PLANT NAME: Surry 1 & 2

Serial No. 211  
FR/JTR:agg

Docket Nos. 50-280  
50-281

CHANGES TO LIMITING VALUES OF POWER  
DISTRIBUTION PARAMETERS FOR CYCLE 3 OPERATION OF  
SURRY UNITS NO. 1 AND 2 AS THE RESULT OF HIGHER UPPER HEAD  
FLUID TEMPERATURES AND THIMBLE CELL ROD BOW EFFECT

Figure 1

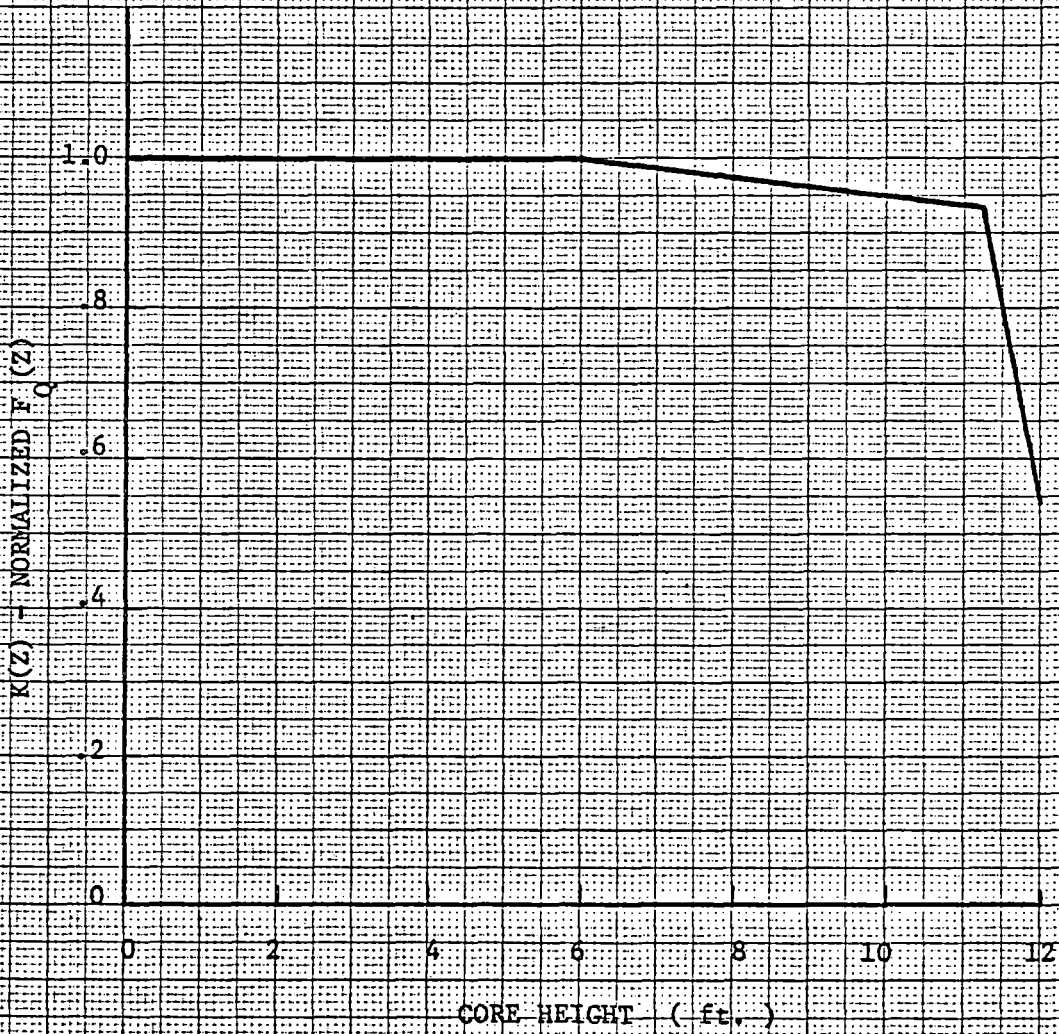
- The heat flux hot channel factor,  $F_Q(Z)$  shall be limited to the following values:

where  $P$  is the fraction of rated power at which the core is operating,  $K(Z)$  is the function given in Figure 1, and  $Z$  is the core height location of  $F_Q(Z)$ . Additionally, the limiting behavior of  $F_Q(Z)$  for nominal transient operation of each unit shall be periodically evaluated. If this evaluation shows that  $F_Q(Z)$  could potentially violate its limiting values either:

For Unit 1

$$F_Q(Z) \leq (1.80/P) \times K(Z) \text{ for } P > 0.5$$

$$F_Q(Z) \leq (3.60) \times K(Z) \text{ for } P \leq 0.5$$

For Unit 2

$$F_Q(Z) \leq (1.82/P) \times K(Z) \text{ for } P > 0.5$$

$$F_Q(Z) \leq (3.64) \times K(Z) \text{ for } P \leq 0.5$$

FIGURE 2

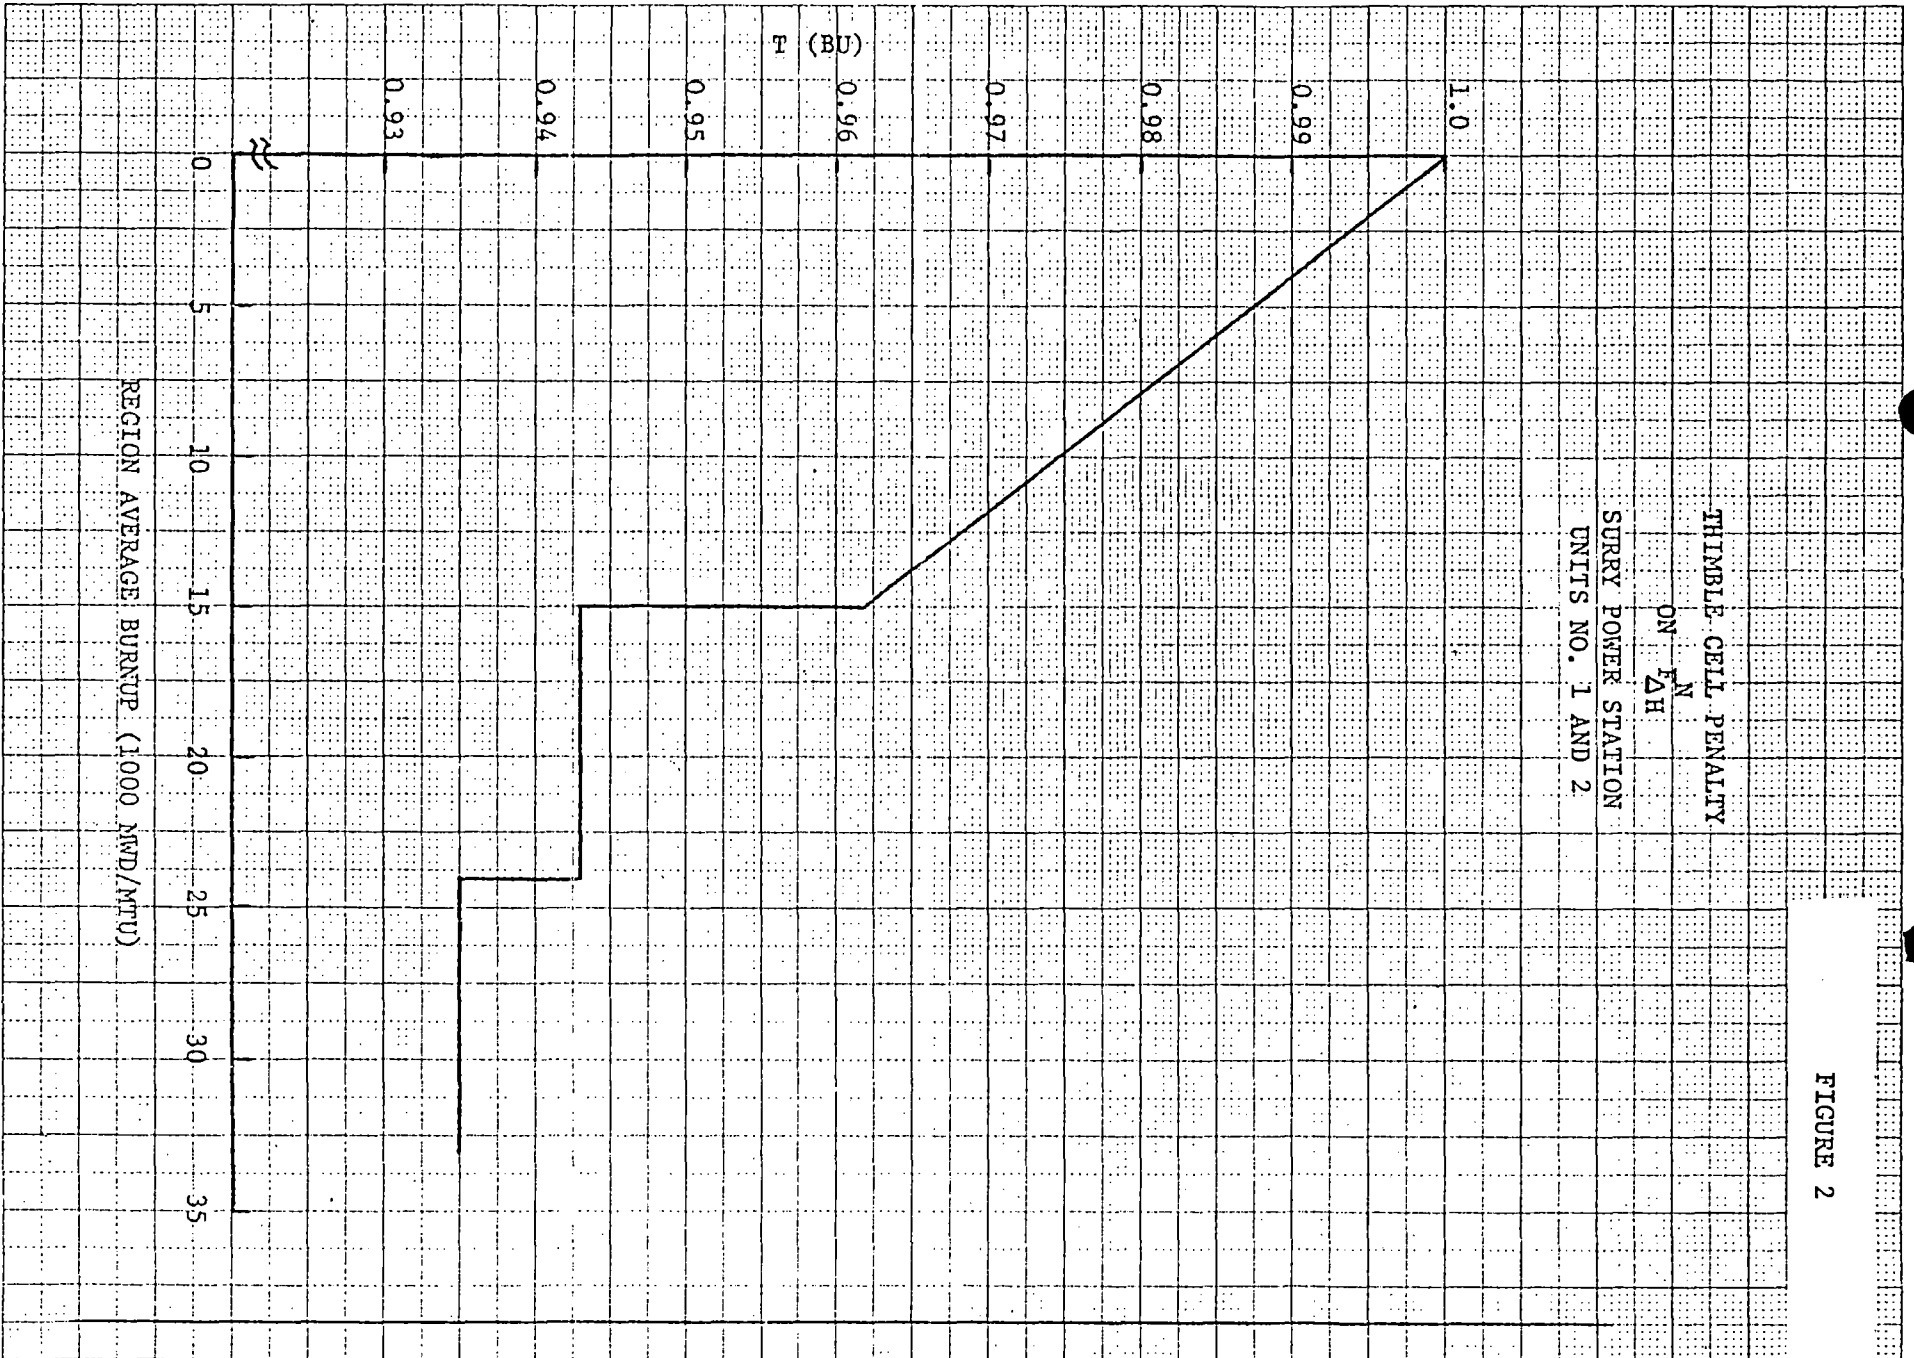
- a. reactor thermal power shall be reduced appropriately in order to accommodate this potential violation, or
  - b. APDMS type surveillance shall be performed to directly monitor  $F_Q(Z)$ .
- The enthalpy rise hot channel factor,  $F_{\Delta H}^N$ , shall be limited to the following values:

where  $P$  is the fraction of rated power at which the core is operating and  $T(\text{BU})$  is the thimble cell penalty on  $F_{\Delta H}^N$ , which is given in Figure 2.

$$F_{\Delta H}^N = 1.55 \{ 1 + 0.2(1-P) \} \times T(\text{BU})$$
